## 2.15 Structures and Servicing Systems

The information in this section of the reference ABWR DCD, including all subsections, tables, and figures, as modified by the STP Nuclear Operating Company Application to Amend the Design Certification rule for the U.S. Advanced Boiling Water Reactor (ABWR), "ABWR STP Aircraft Impact Assessment (AIA) Amendment Revision 3," dated September 23, 2010 is incorporated by reference with the following departures.

Table 2.15.5c Reactor Building Safety-Related Equipment HVAC System

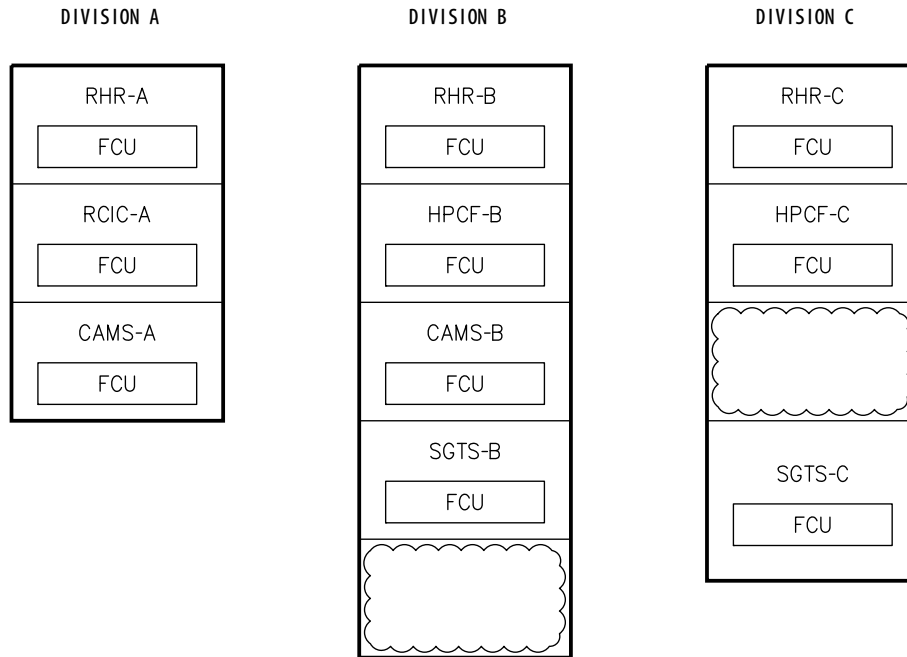
Inspections, Tests, Analyses and Acceptance Criteria		
Design Commitment	Inspections, Tests, Analyses	Acceptance Criteria
<del>4. The FGS room FCUs are initiated upon a manual FGS start signal. Not used.</del>	<del>4. Tests will be conducted on each as built FGS room FCU using a simulated initiation signal. Not used.</del>	<del>4. The FGS room FCU starts upon receipt of a signal indicating FGS start. Not used.</del>

**Figure 2.15.5e Reactor Building Safety-Related Equipment HVAC System**

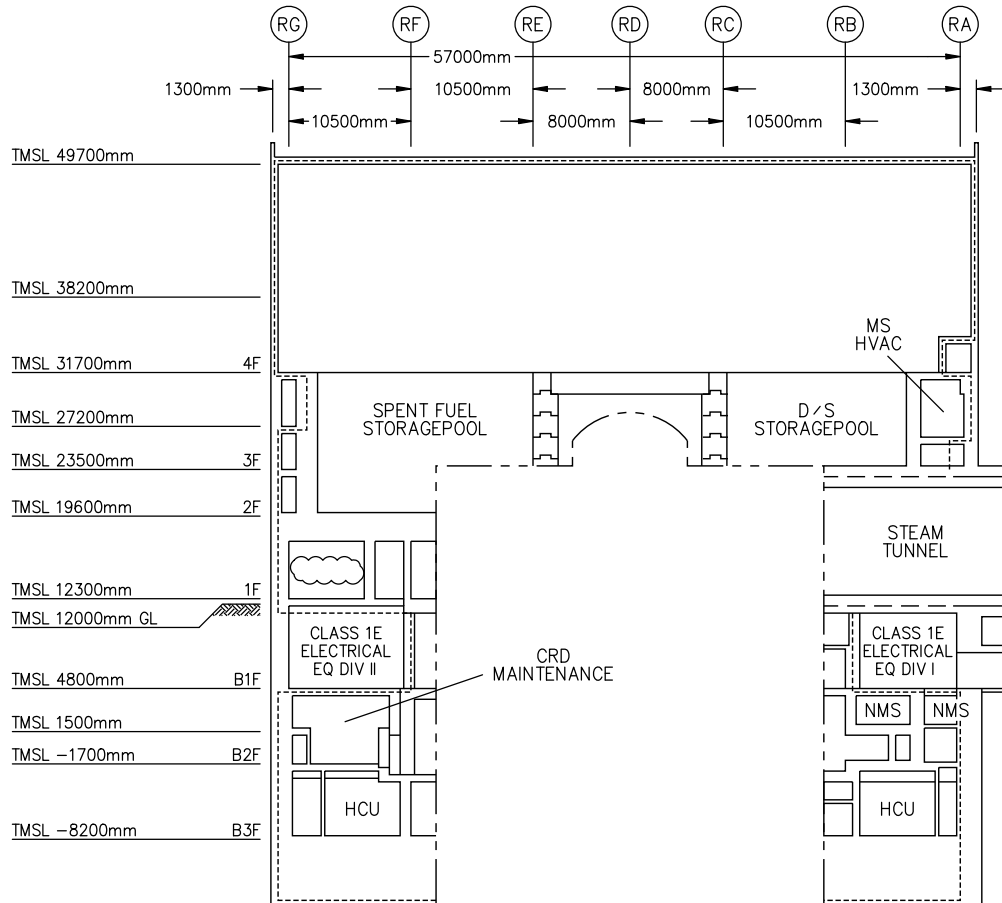
STD DEP T1 2.14-1 (Figure 2.15.10a, Figure 2.15.10j, Figure 2.15.5e, Table 2.15.5c)

*The R/B Safety-Related Equipment HVAC System provides cooling of safety-related equipment areas, and consists of independent fan coil units. Figure 2.15.5e shows the basic system configuration and scope.*

*The Residual Heat Removal (RHR) System, High Pressure Core Flooder (HPCF) System and Reactor Core Isolation Cooling (RCIC) System pump room FCUs are automatically initiated upon startup of their respective room process pump. The Containment Atmospheric Monitoring System (CAMS) and Standby Gas Treatment System (SGTS) room FCUs are automatically initiated upon isolation of the Reactor Building Secondary Containment HVAC System. ~~The Flammability Control System (FCS) room FCUs are also initiated upon a manual FCS start signal.~~*

Figure 2.15.12a Control Building Arrangement, Section A-A

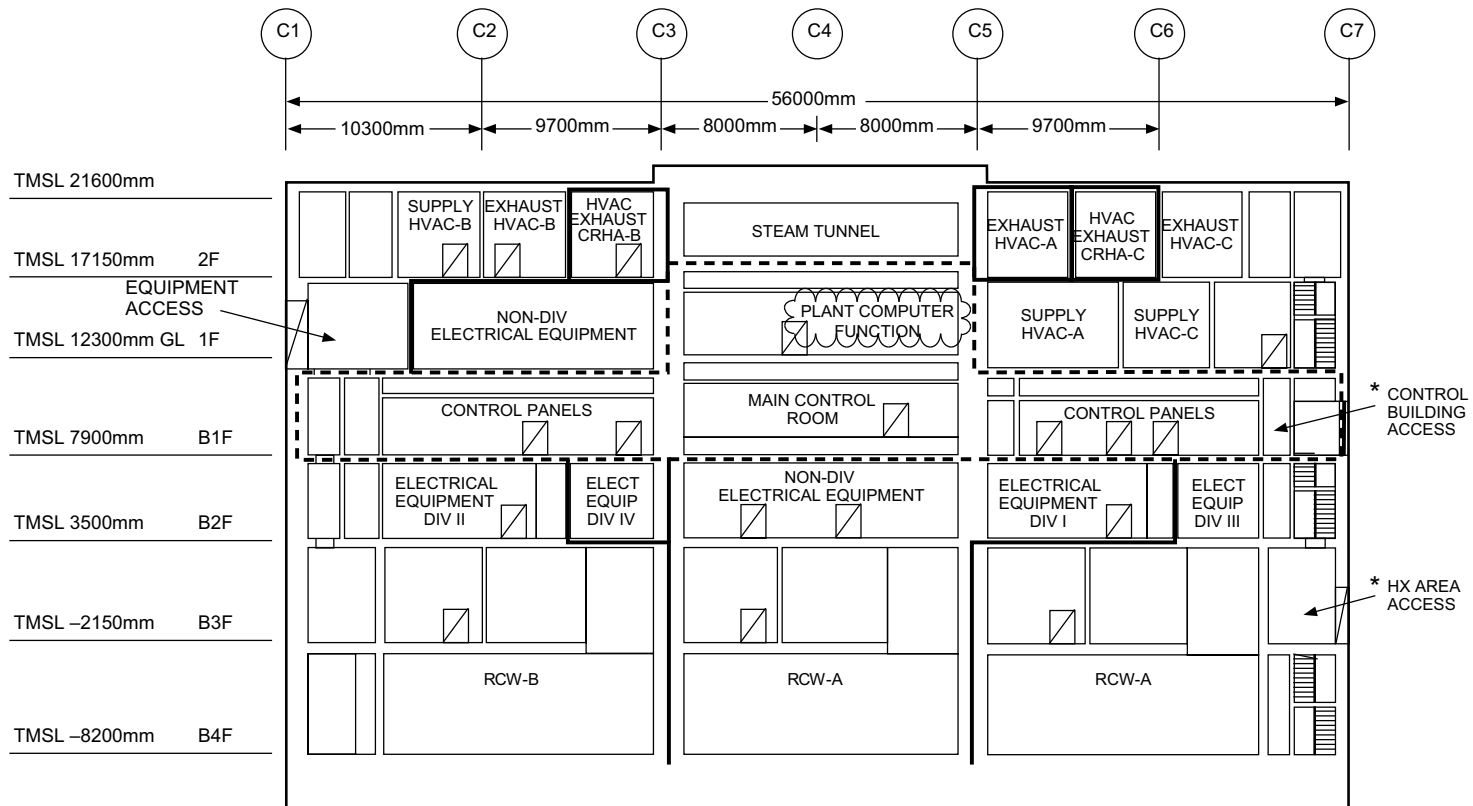
STD DEP T1 3.4-1 (Figure 2.15.12a, Figure 2.15.12b, Figure 2.15.12g)
